CITY OF SACRAMENTO

Permit No: 0600815

Site Address: 380 36TH WY SAC
Parcel No: 004-0173-009

Nature of Work: REMODEL BATHROOM, REPLACE & RELOCATE TUB CHANGE OUT FIXTURES. REPLACE WINDOW (SIZE FOR SIZE).

COLLADA - EXISTING BATH FLOOR PLAN - 1/2"=1'0"

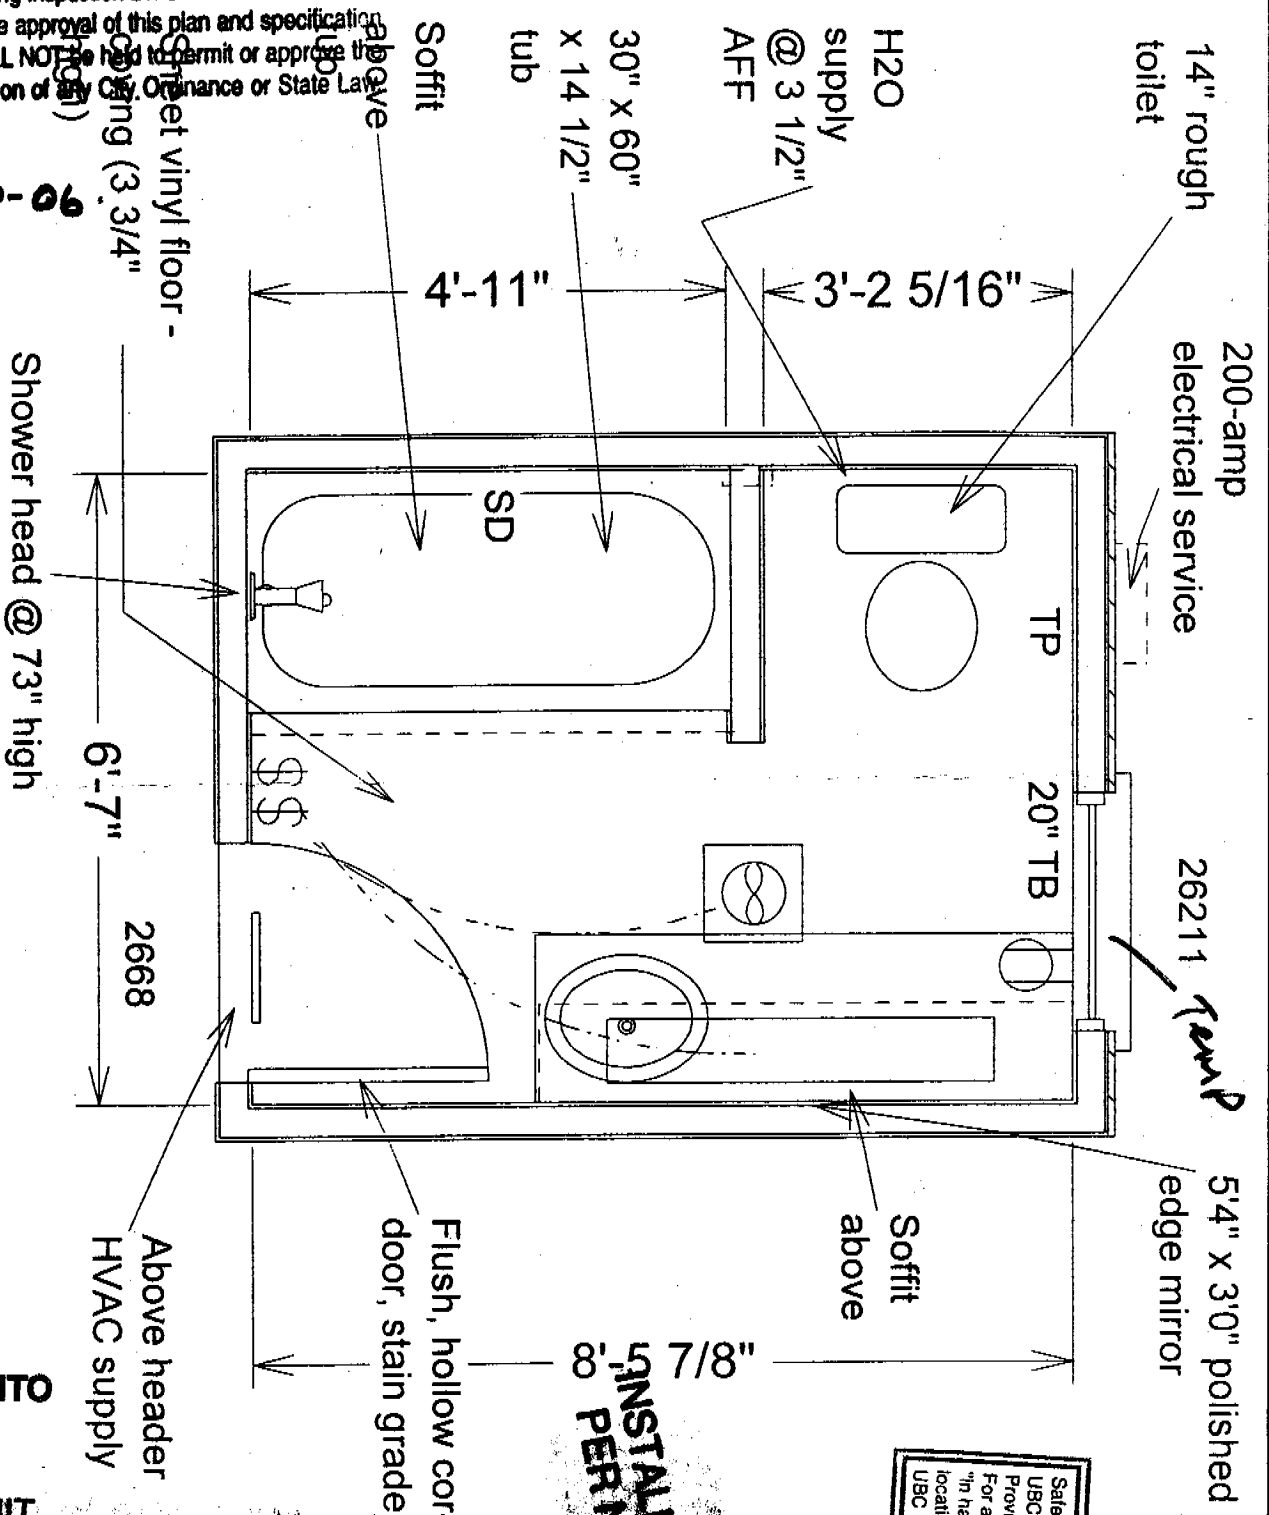
INSTALL ALL GFCI
PER NEC 210-8

Safety Glazing
UBC 2406.4.9
Provide Safety Glazing
For all glazing
"in hazardous
locations" as per
UBC Section 2406

COLLADA - NEW BATH FLOOR

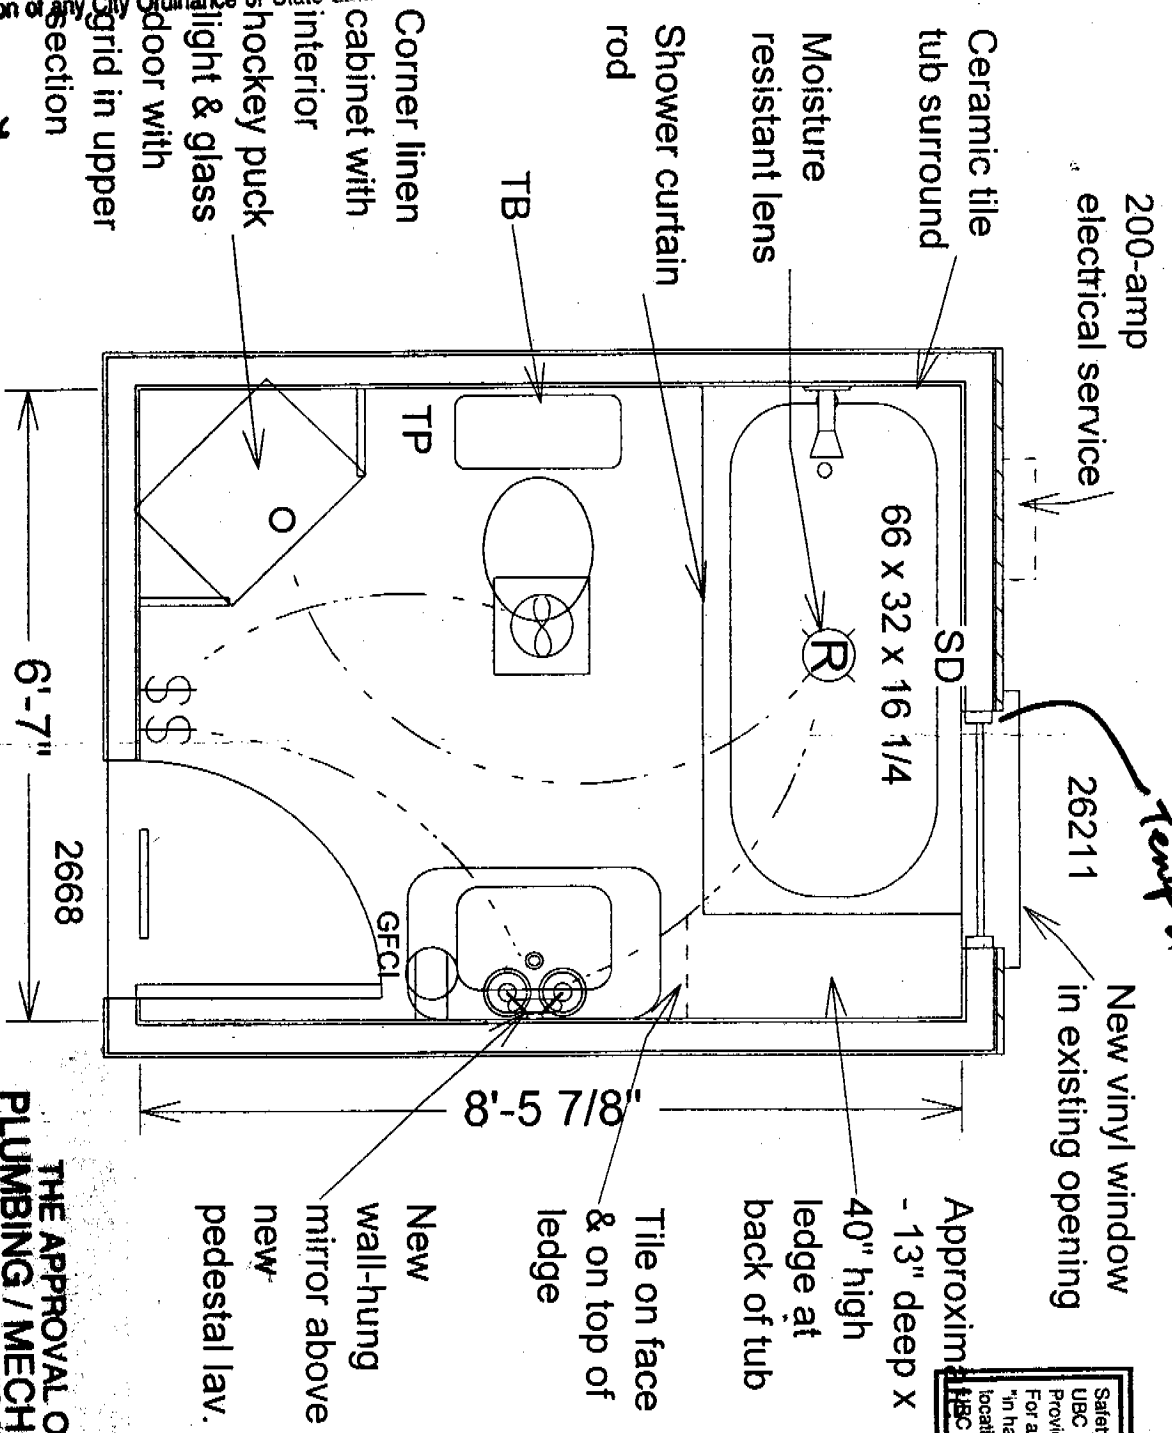
Safety Glazing
UBC 2406.4.9
Provide Safety Glazing
For all glazing
in hazardous
locations as per
IBC Section 2406

INSTALL ALL GFCI
PER NEC 210-8
